## **A. Statement of Technical Rationale and Justification**

### B. Text of Regulations

**Figure 2: Example WNTE Control Area**

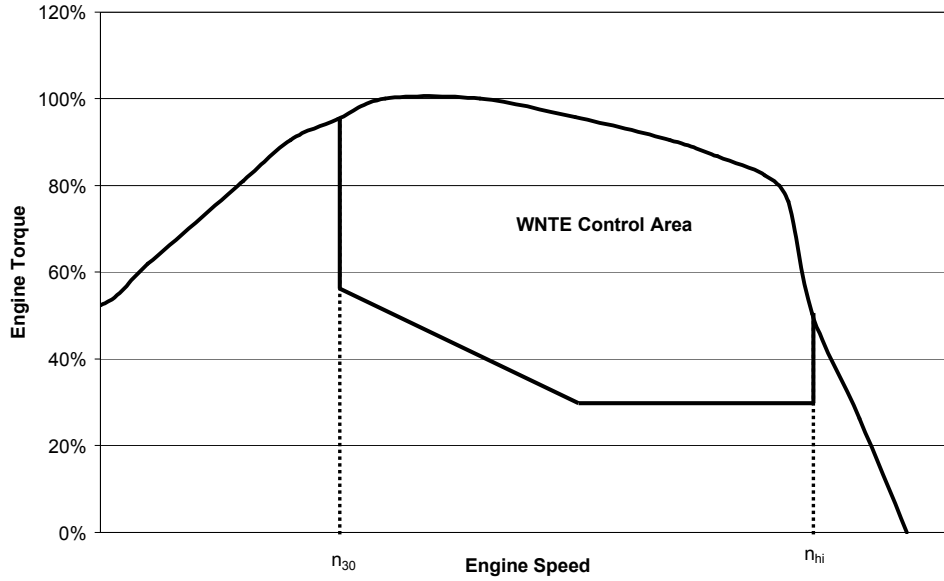
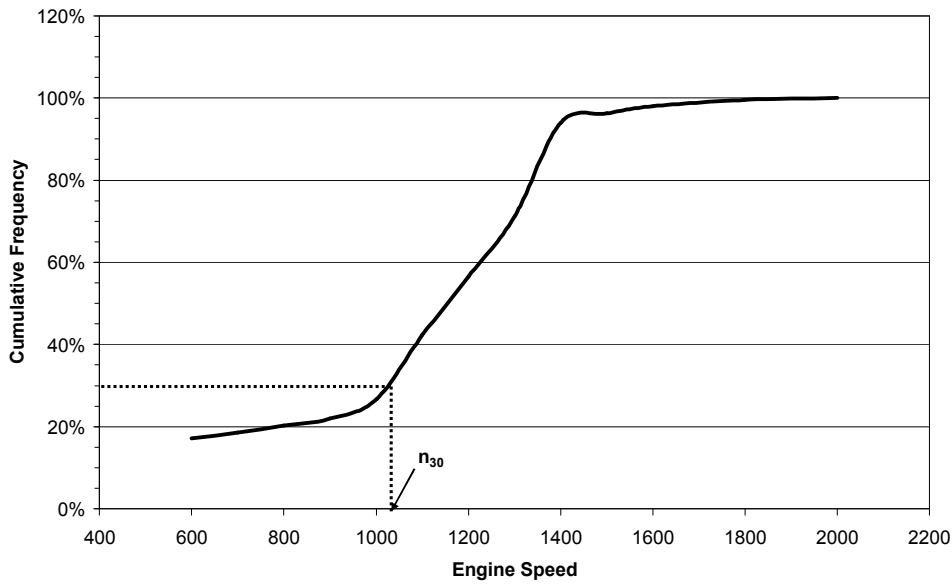
**Editorial Comment: Update figure 2 and 3 to correspond with final control area established in gtr.**

Figure 5: WNTe test cycle grids [new figure to be provided by EC]

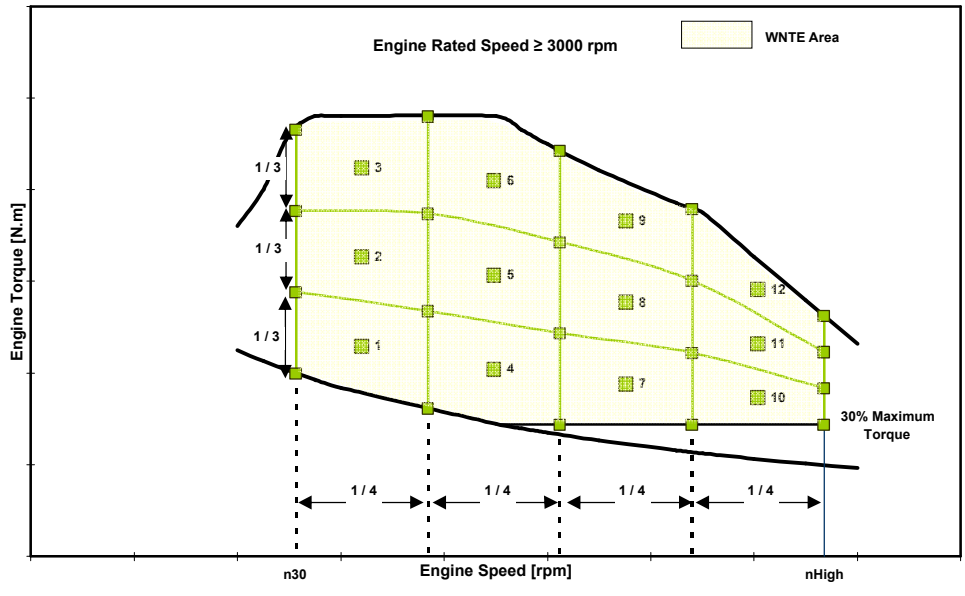
An example of the grid applied to a specific engine is shown in Figure 5. [examples of both the 9 and 12 grid figures will be provided by the EC]
